Attorney Docket No. LKMP:112US
U.S. Patent Application No. 10/613,172
Reply to Office Action of March 24, 2005
Amendment and Request for Reconsideration dated: May 3, 2005

Amendments to the Drawings

Remarks/Arguments

Fig. 2

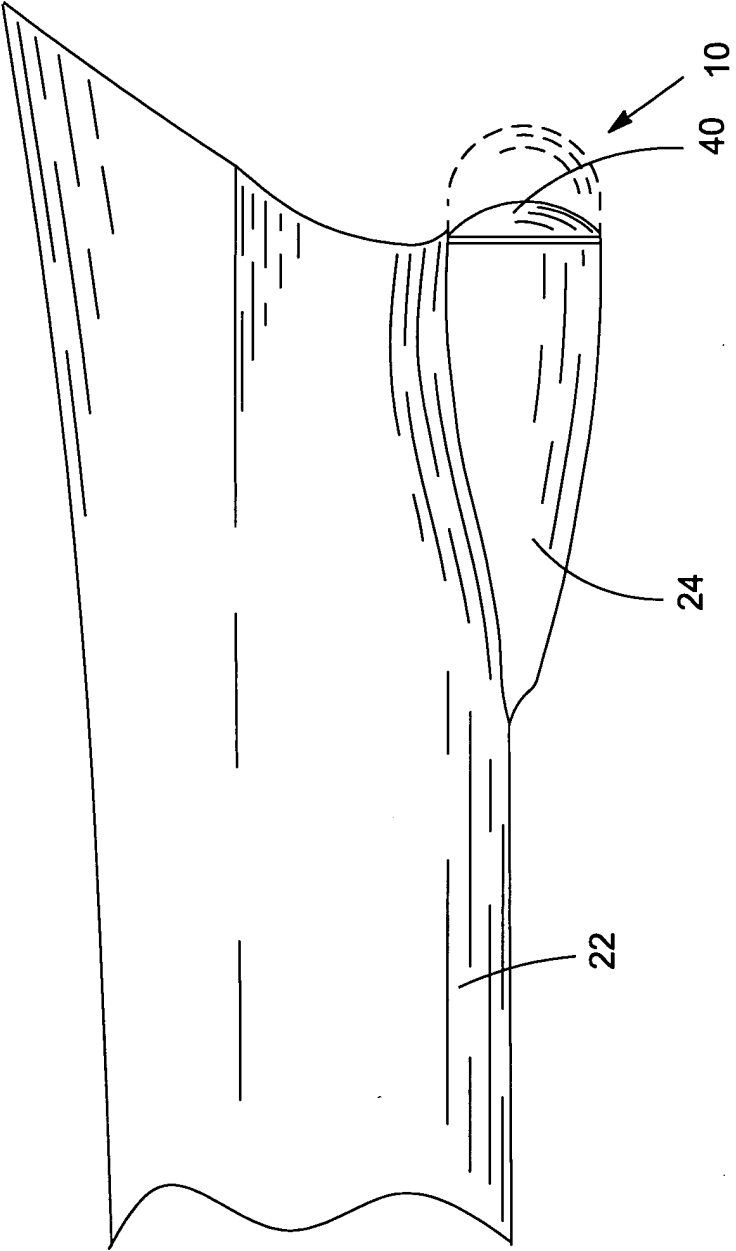
Each sheet is labeled "REPLACEMENT SHEET." A waterline has been added to and labeled in drawings 2, 8A, 8B, 9A, 9B, 10, 11, 12, 12A, 13, 14, and 15 to show the subject vessel as floating upon a water surface or being submerged below a water surface. Applicant requests that the objection be removed.

Fig. 6C

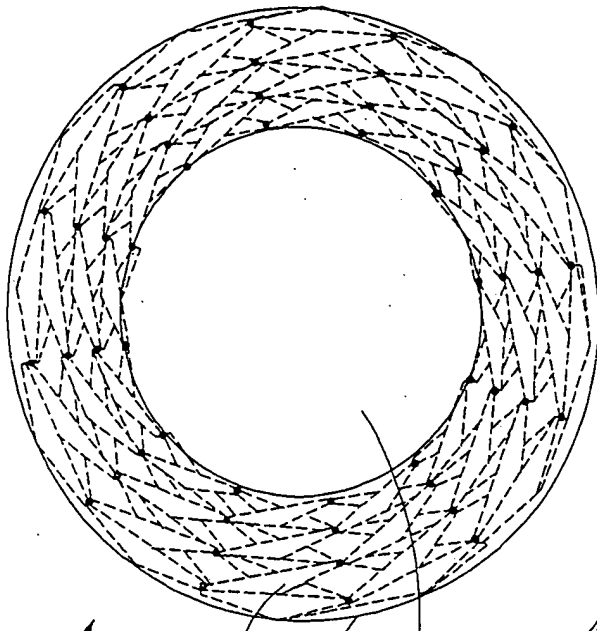
The Examiner requested that annotated sheets, showing the changes made in the Replacement Sheets provided in the reply of February 15, 2005, be provided under 37 CFR 1.121(d)(1). Applicant has provided a full set of the drawings for this purpose. The drawings are labeled “ANNOTATED SHEETS” and show the drawings as they were at the time of the August 26, 2004 Office Action response. The changes made to Figures 6A, 6B, 6C, 10, 11, 12, 12A, 13, 14, and 15 in the February 15, 2005 reply are hand marked and hand labeled.

Fig. 6B

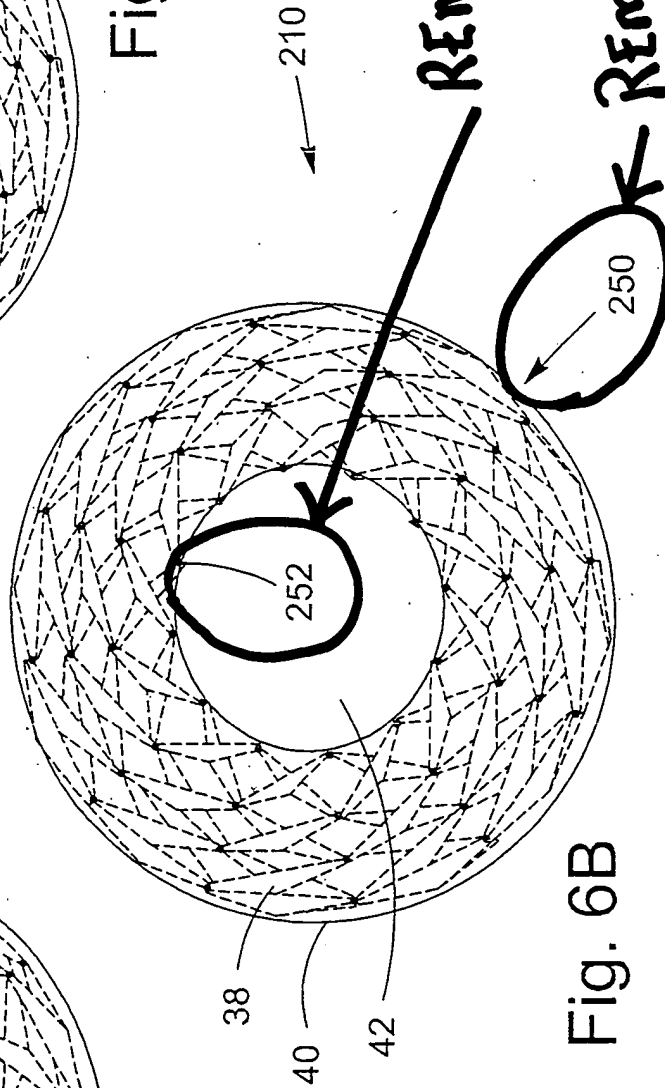
REMOVED

REMOVED
